BLM SCALAR FIX -Based on findbhudda's original design:
http://www.midibox.org/dokuwiki/doku.php?id=findbuddha

DESIGN FILES:
Corrected blm-scalar v1.1.brd below & attached: blm-scalar_v1.1.zip

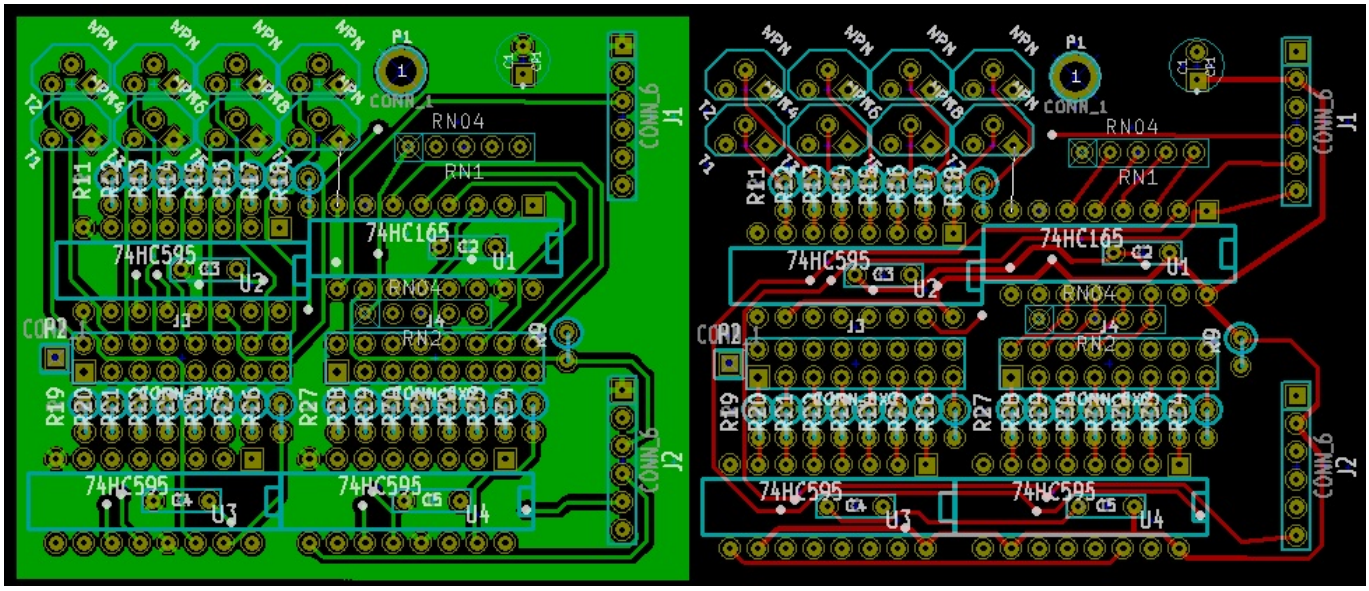
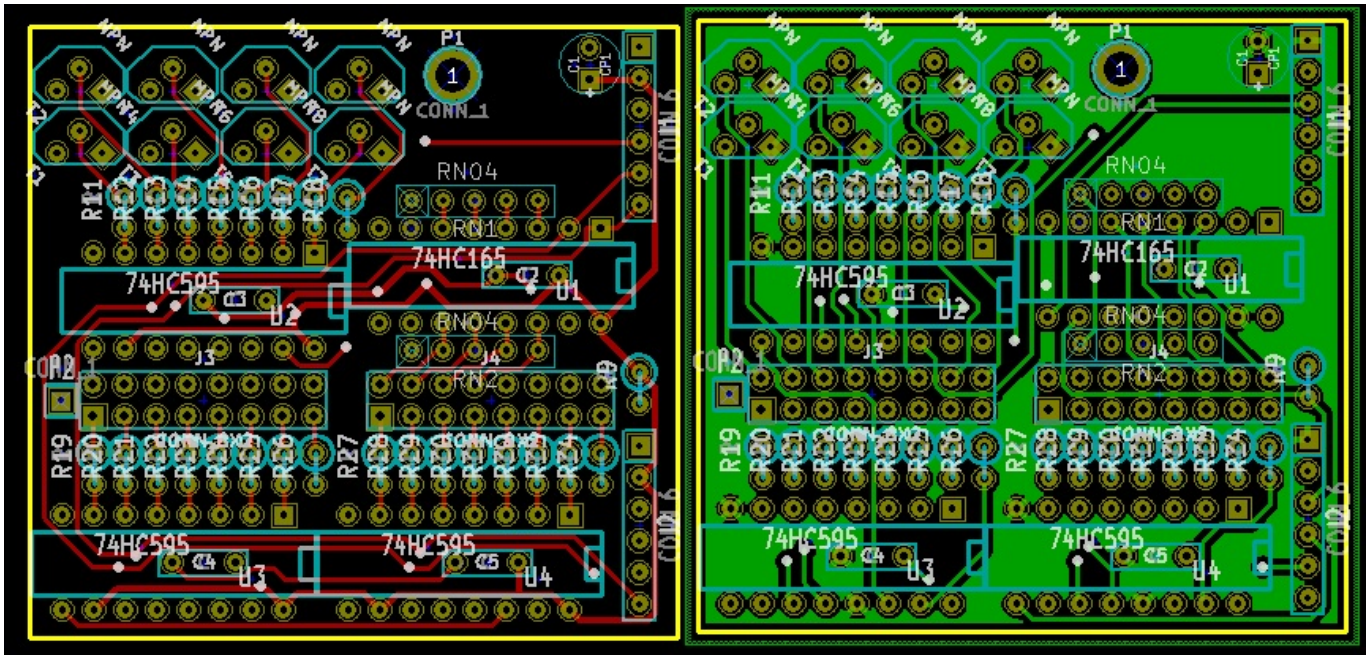
KNOWN ISSUES / BUILD SUGGESTIONS:
- blm-scalar.* contain an error. Pins I4-I7 are mirrored. This is easily fixed with a connector modification, and the blm-scalar module seems to work as intended.
- blm-scalar v1.1 attempts to fix this error. Moved connectors J1, J2 & Resistor Net 1 to make room for corrections.
